# ASH ELEVATION E

# PRINCE PLACE LOT 16

2387 - ASH - RH  
-----  
Coversheet 'E'

ASH  
PLAN 2387  
DAVIDSON HOMES

## TRUSS BLOCKING DETAIL

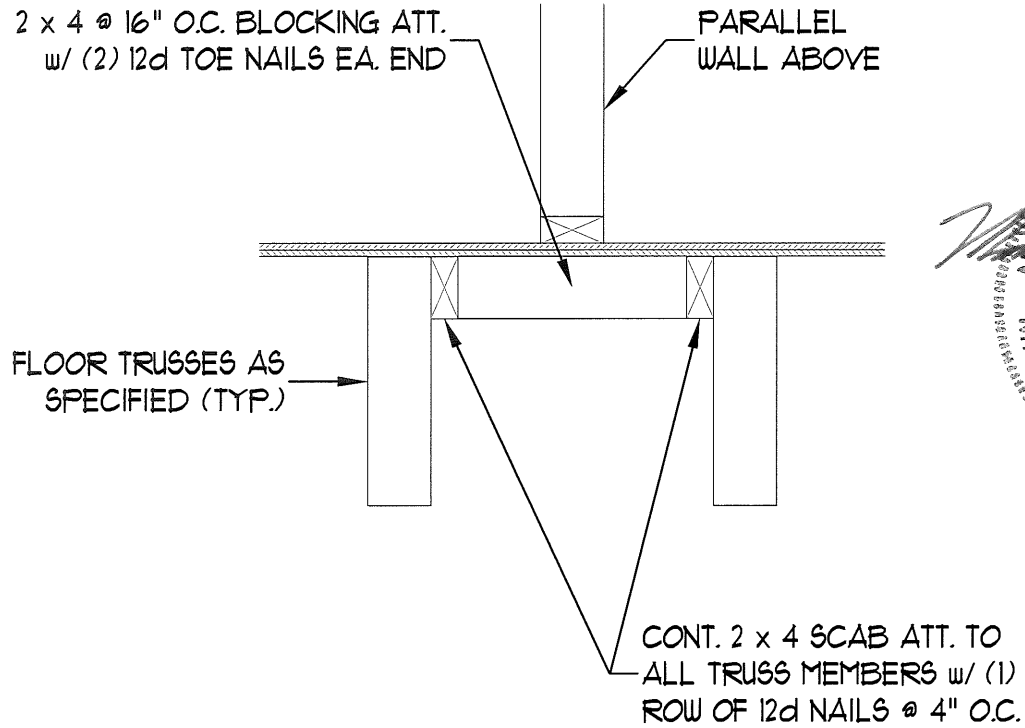
The plans listed above were reviewed to address the use of floor trusses for the second-floor system.

Analysis revealed 14" open-web floor trusses engineered by others at 24" o.c. may be used in lieu of the plan specified 14" TJI 210 I-joists. If tile flooring is used in any area, install a 2 x 4 scab at the top of adjacent floor trusses and fasten to all members with (1) row of 12d nails at 4" o.c. Install 2 x 4 blocking at 16" o.c. between the scabs with (2) 12d toe nails at each end. Support walls parallel to the floor trusses per the attached detail. This configuration will provide the required support for all applied loads.
